**ZONING MAP CHANGE
STAFF REPORT**

Site Location: 4908 & 4912 E. Rosedale Street Mapsco: 79JK

Request: From: "E" Neighborhood Commercial
To: "PD/D" Planned Development for all uses in "D" High Density Multifamily with waivers and urban development standards, site plan included.

ZC-16-095

A201 - 3.59 ACRE SITE

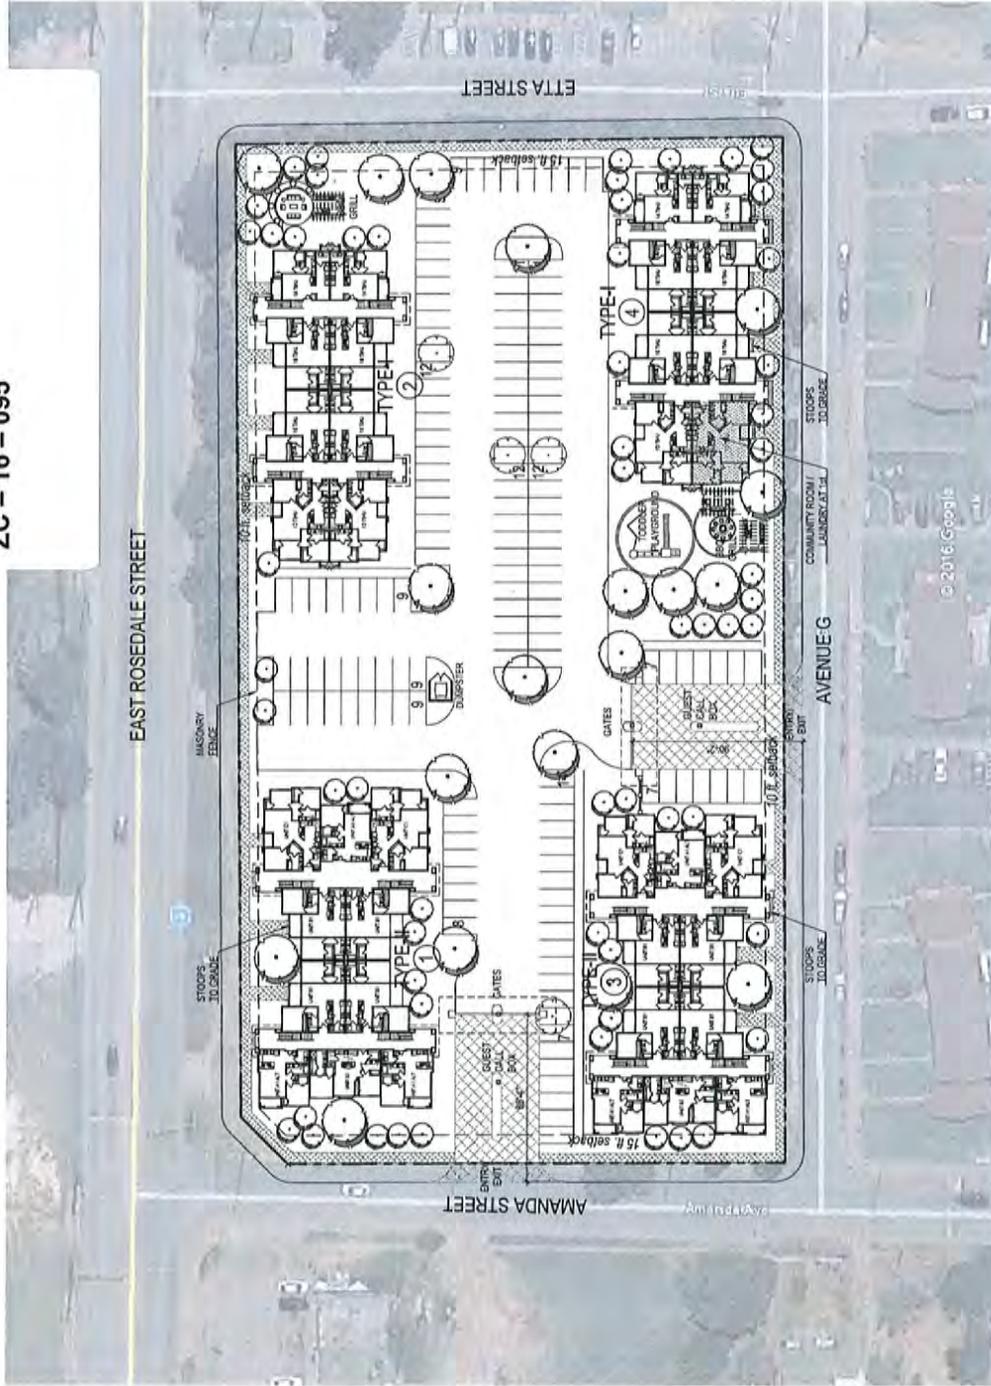
1. 20 ft. setback along all frontages (**waiver requested**).
2. Roughly 29 units per acre (**waiver requested (24 units per acre in D)**)

1. Subdivisions containing more than thirty (30) one-family or two-family dwelling units shall have a platted and constructed secondary ingress and egress to a public street. Multi-family developments of 100 dwelling units or more shall have a platted and constructed secondary ingress and egress to a public street.

2. Gated entrances into secured areas must be designed in accordance with TPW's "Traffic Engineering Design Standards and Policy Guidelines". Provisions for an acceptable turnaround must be made. Provide details in IPRC plan set (single-family) or UR site plan (multi-family) for gates. All gates shall be equipped with a knock-box or other approved fire access apparatus that is reviewed and approved by the Fire Department. (Gates must be located 3 vehicle lengths from the ROW). The proposed gates on Amanda and Avenue G do not comply with TPW stacking requirements.

3. On street parking may be permitted within city right-of-way with approval of design and location by TPW. On-street parking is not guaranteed nor can it be reserved for a specific site. TPW recommends that on-street parking provided not be counted towards minimum parking requirements because it is available for the public in general.

4. TXDOT permit is required for work in and along State ROW. Street connections to TXDOT ROW is contingent upon TXDOT approval. TXDOT approval required for any proposed interchanges and/or driveway access to TXDOT facilities if access is proposed on Rosedale.

5. Sidewalks and street lights are required for all public and private streets and public access easements as per City of Fort Worth Standards. Sidewalks are required along all street frontages.

1. All gates shall comply with Section 503.6 of the CFW Fire Code.
2. Show dimension of fire lane near each building. A minimum of 26' wide fire lane is required for all multifamily buildings.
